STAFF REPORT
CITY OF BEVERLY HILLS

**For the Design Review Commission
Meeting of April 1, 2010**

SUBJECT: A request for an R-1 Design Review Permit to allow a new, two-story single-family residence located in the Central Area of the City, south of Santa Monica Boulevard at **265 South Wetherly Drive.** (PL 100 0935)

Previously Proposed Elevation 2/4/10

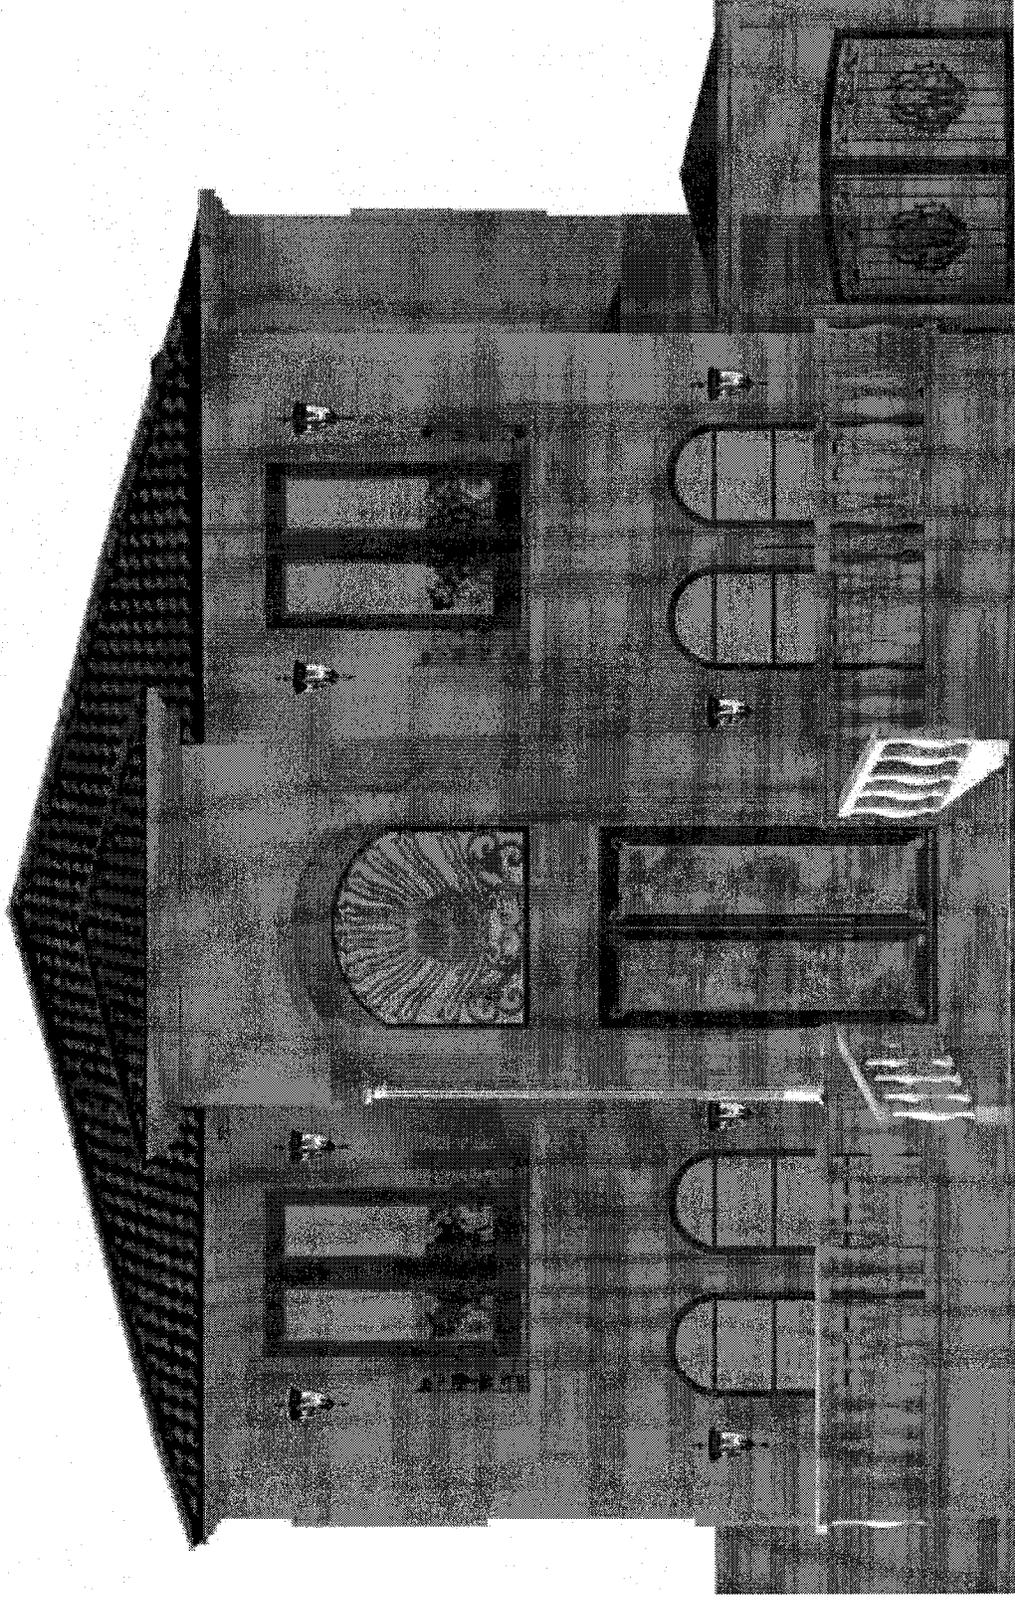
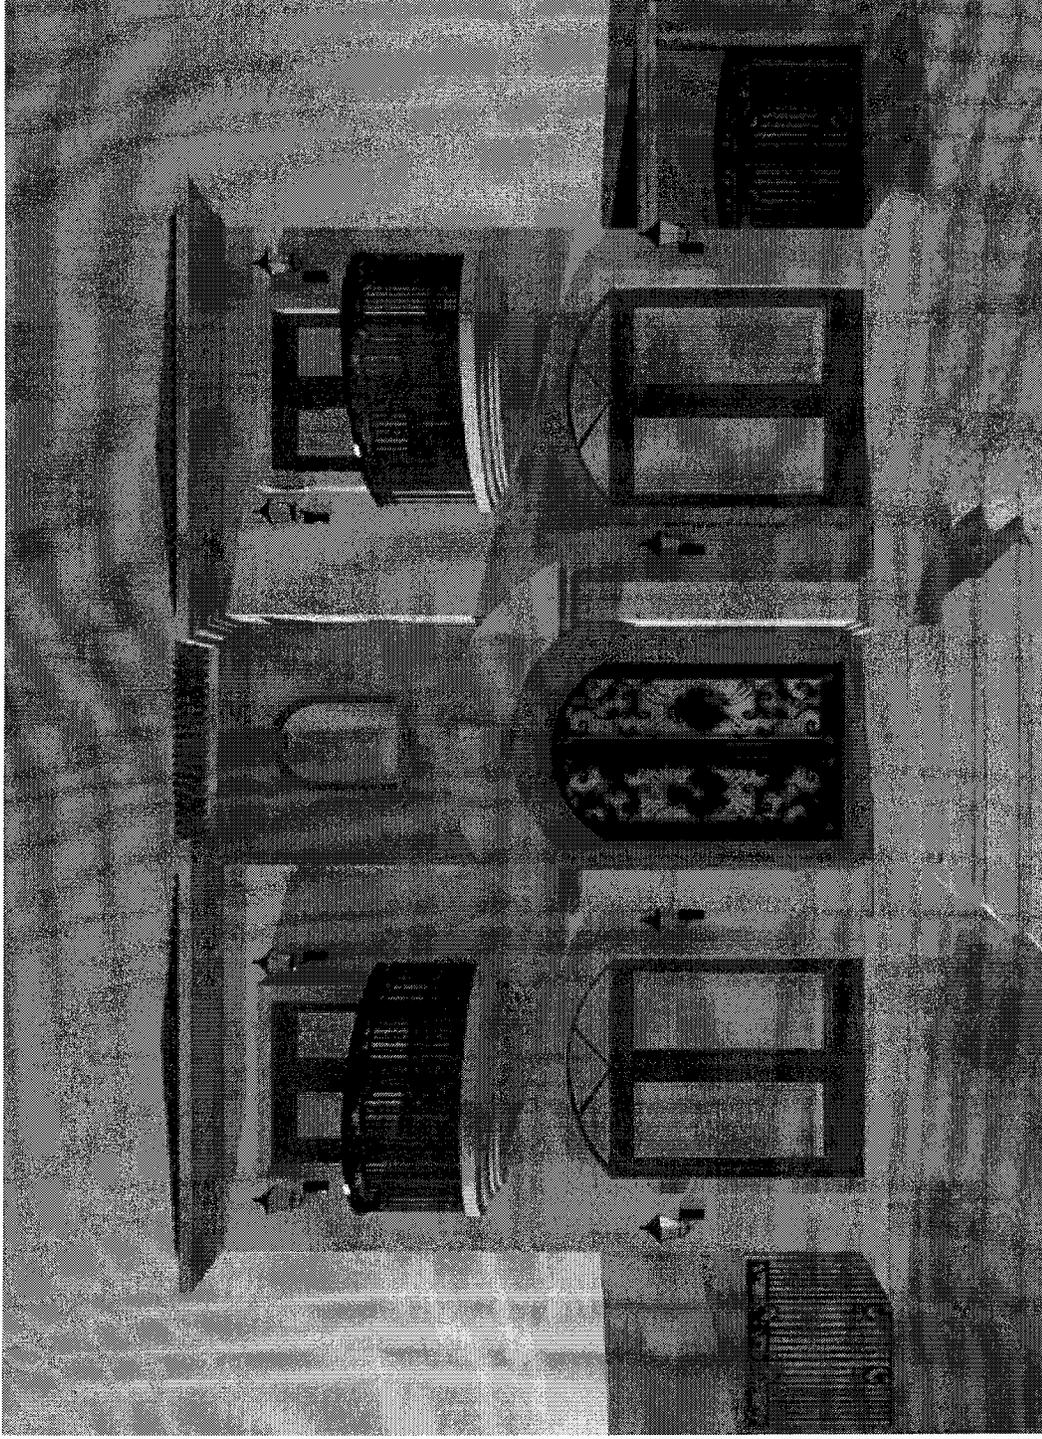
| Design Review Commission Requests March 4, 2010 Meeting | Applicant's Response |
|--|---|
| 1. The number of exterior lights should be reduced to two large lights on each side of the entry. 2. The French Doors are over-scaled and compete with the front door. 3. The window over the entryway needs to be more fully developed. 4. The entry pediment and columns need to be further developed. 5. The keystone needs to be refined. 6. The proportions of the architectural surrounds around the French doors should be consistent in width. 7. The metal entry door is overly ornate. 8. The style of the second story balconies (rounded in shape, 'steps' at the bottom of the balcony) does not fit with the other elements of the design. 9. Provide information about front yard fencing being proposed. | 1. All exterior lighting with the exception of the two sconces adjacent to the entry was removed. 2. The French doors at the ground floor were replaced by two large picture windows. The second story French doors remain unchanged. 3. No changes have been made to the window over the entryway. 4. The entry pediment and columns have been redesigned. 5. The keystone has been removed. 6. The width of the architectural surrounds for the windows and doors are now consistent. 7. A more simple wrought iron entry door is proposed. 8. The balconies have been squared. 9. No walls, fences or hedges are being proposed. |

1. Pursuant to Beverly Hills Municipal Code §10-3-2408 (F), the architectural projections can project no further into the front yard setback than 10% of the front setback depth. As such, the balconies shall be setback 6 inches so as to conform with the permitted 2'-6" encroachment.
2. Pursuant to Beverly Hills Municipal Code §10-3-2408(F-1), no walls, fences or hedges located in the front yard shall exceed 3 feet in height.
3. Pursuant to Beverly Hills Municipal Code §10-3-2408(F-2), architectural projections which encroach into the front yard shall cover no more than twenty percent (20%) of the maximum potential facade of the building, except as permitted by a Central R-1 permit.

4. Pursuant to Beverly Hills Municipal Code §10-3-2408(F-3), all paving within the front yard shall conform to the requirements of BHMC §10-3-2422 for properties in the Central Area of the City, South of Santa Monica Boulevard.
5. An additional parking space must be provided on the property so as to comply with Beverly Hills Municipal Code §10-3-2419, which requires three parking spaces be provided for a single-family residence containing five bedrooms.
